SUNDRY NOTICES AND REPORTS ON WELLS (DO NOT USE THIS FORM FOR PROPOSALS TO DRILL OR TO DEEPEN OR PLUG BACK TO A DIFFERENT RESERVOIR. USE "APPLICATION FOR PERMIT" (FORM C-101) FOR SUCH PROPOSALS.)		WELL API NO. 30-045-21674

San Juan Resources is proposing to permanently plug and abandon the Apperson #1 as per the attached procedure.

P&A Procedure

San Juan Resources – Apperson #1

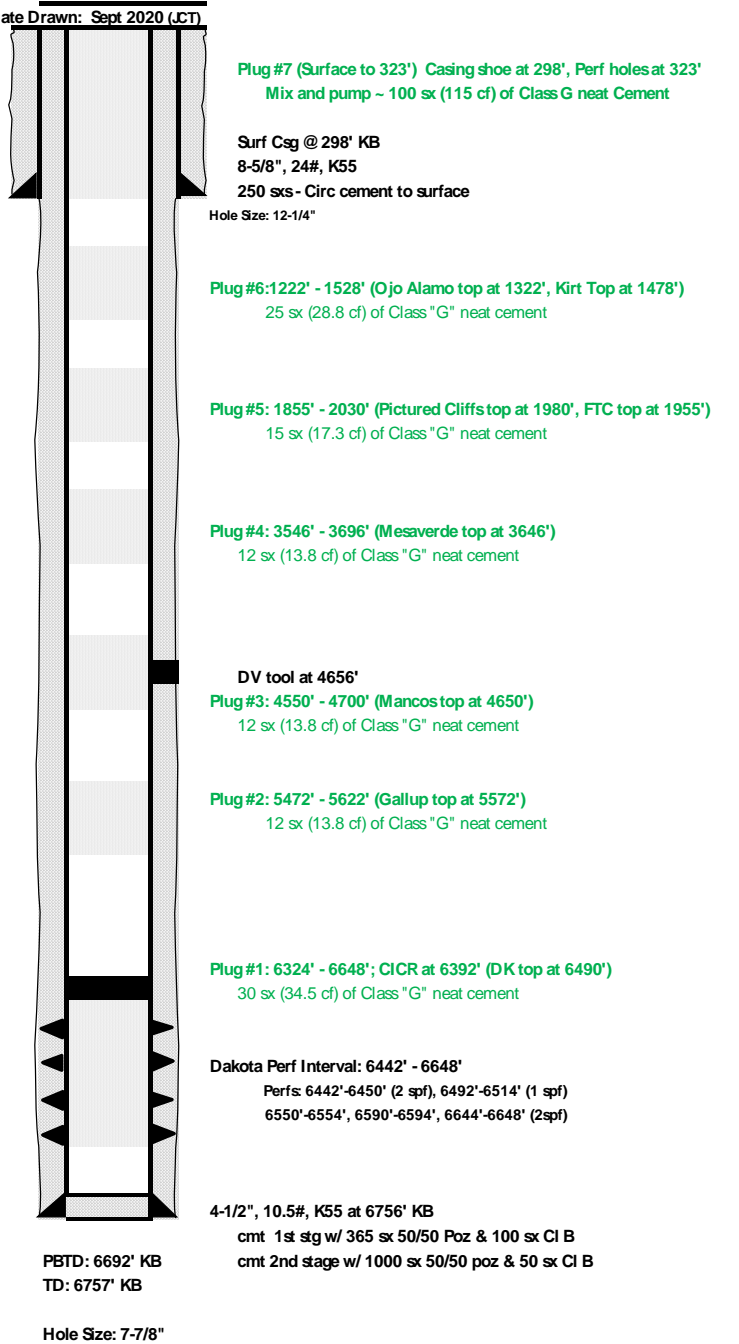
COAs: ***A Pressure test is required after the WOC of each plug until the Casing Pressure tests.

- CBL required
- Extend Plug #1: 6648'-6330'. OCD Graneros pick @ 6434
- Add a plug: 2740'-2640'. OCD Chacra pick @ 2690'.
- Add a plug 1690'-1590'. OCD Fruitland pick @ 1640'.
- Add a plug 790'-460'. OCD Kirtland pick @ 659, Ojo Alamo pick @ 510'.
